Job Stamp 04-0120F4 SFOBB SAS

Assistant Structure Rep.'s Daily Report

Location & Description of Operation	SAS-Temporary towers, Tower A & B Erection			
Weather	HI: 72 F	Low: 58 F	Partly cloudy

Attachment #1

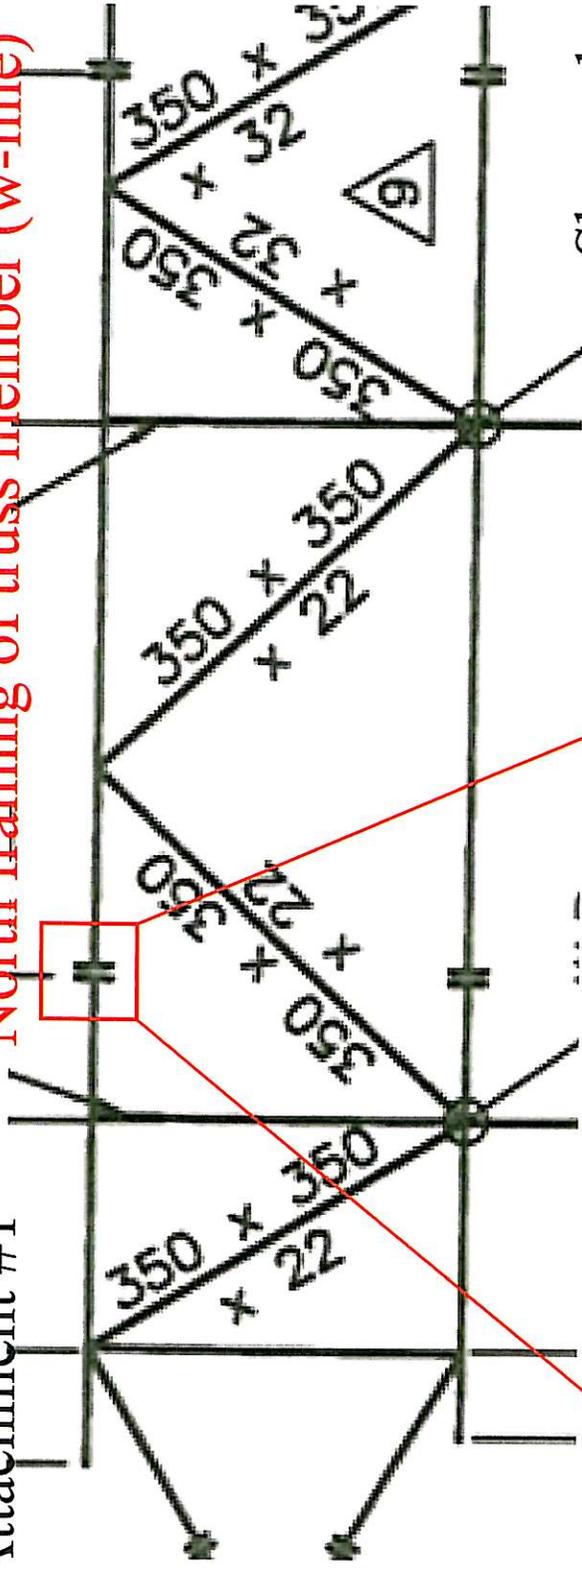
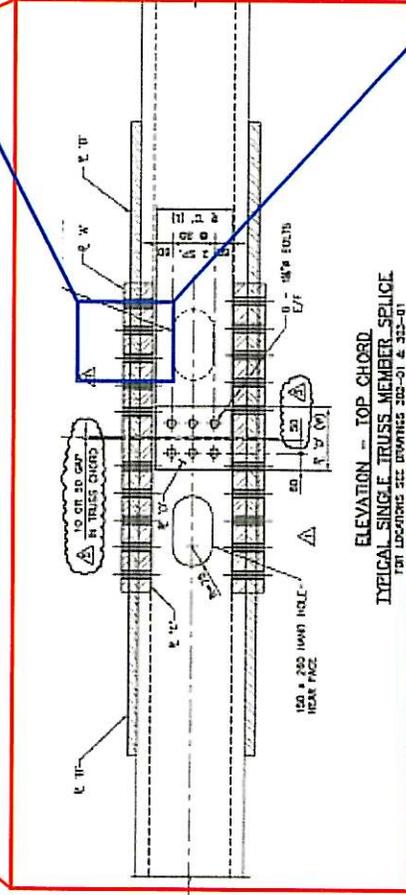
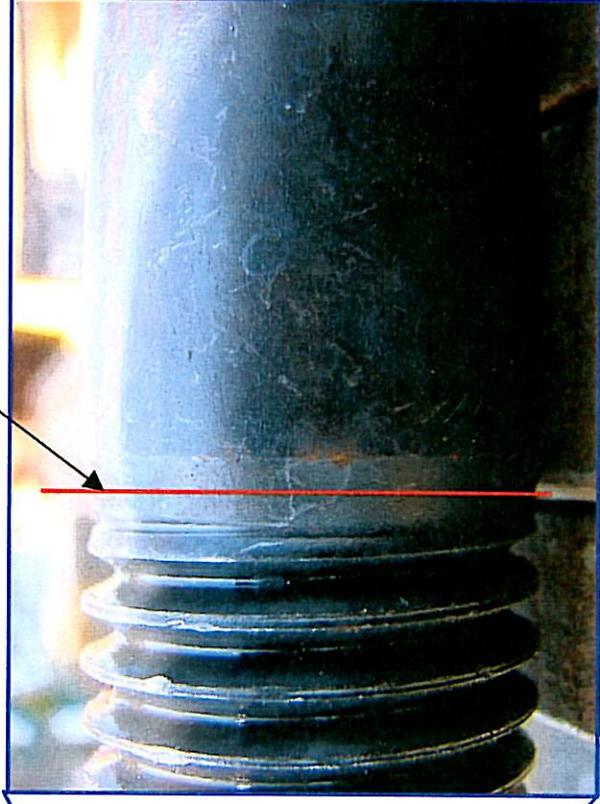
- See Art Pannu's diary for additional contractors' activities and comments.
- Note
 - Noticed that shear plane is located at either run-out or threaded region of bolts at various locations (see attachments #1 and 2). Inform Dan and Ed regarding them. They refused to correct them.

Shear plane

- Shear plane is located at run-out.
- Total number of bolts is 48

Attachment #2

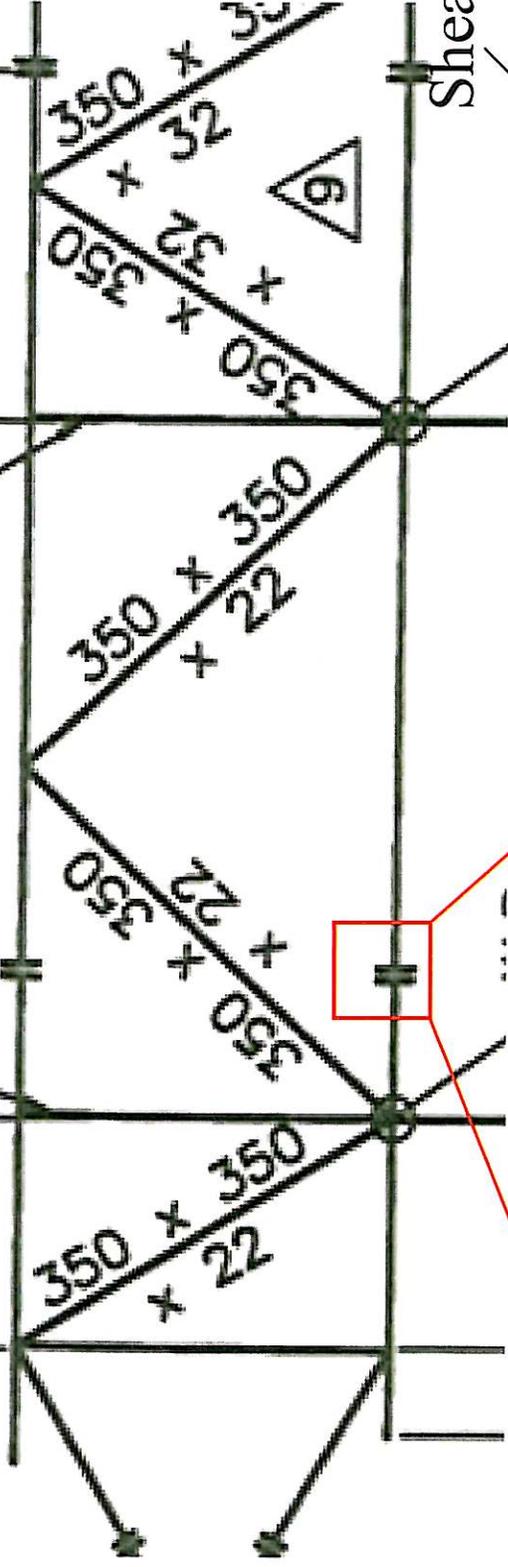
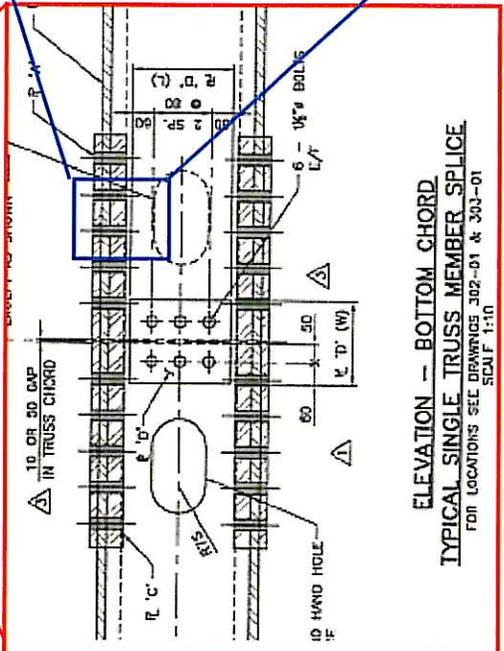
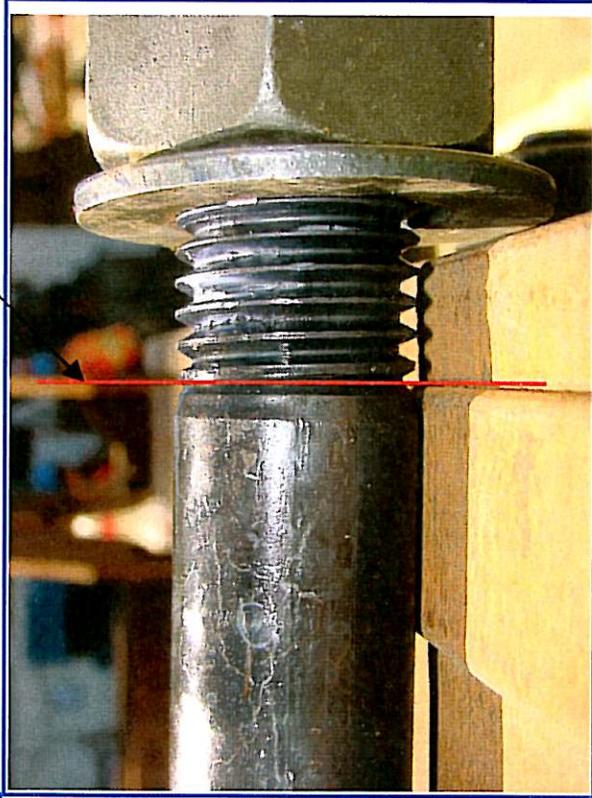
Shear plane

- Shear plane is located at thread region.
- Total number of bolts is 48

Attachment #4

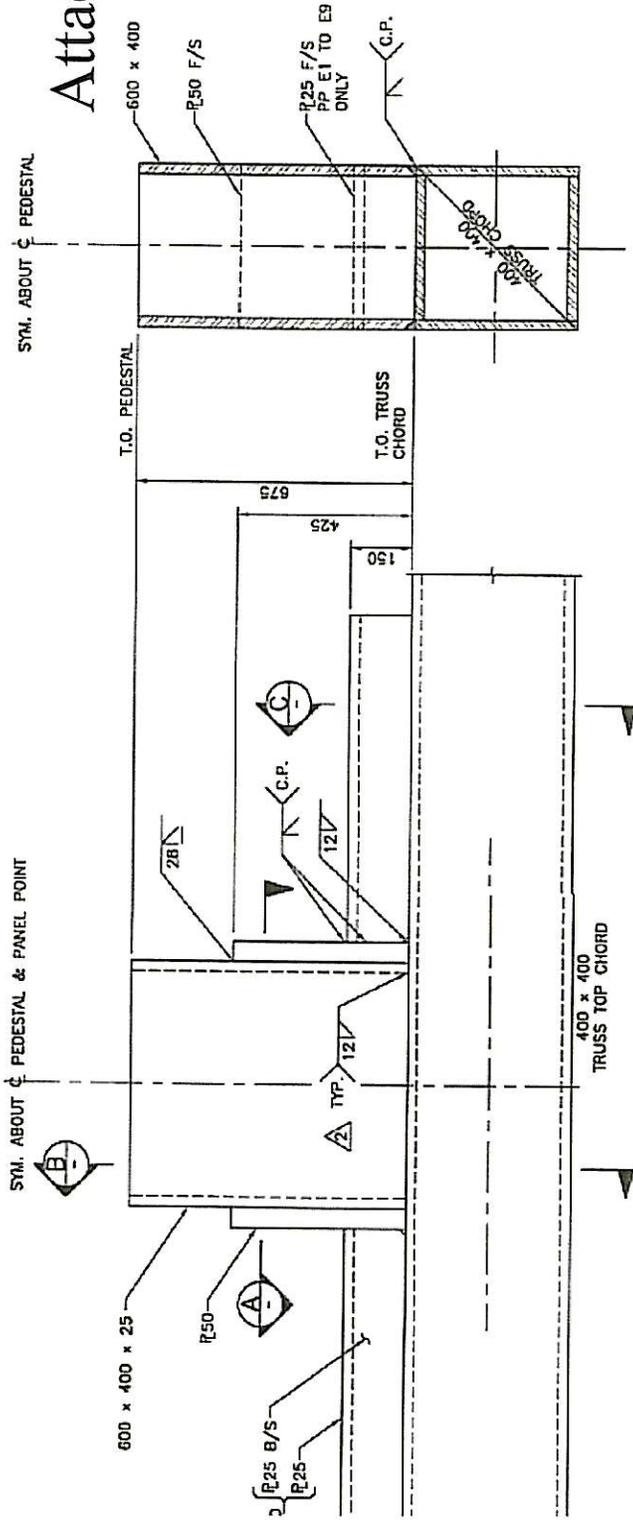
- The pedestal has 8 holes on each side, while design plan shows no holes (see attachment #4).
 - 2 hours O.T.
- Punch list
 - The right top bolt of the east side plate of the tower A west line should be turned more (see 07/22/08 diary for more information).

- DWG 602-01 doesn't show any hole, while actual pedestal has eight holes on each side.
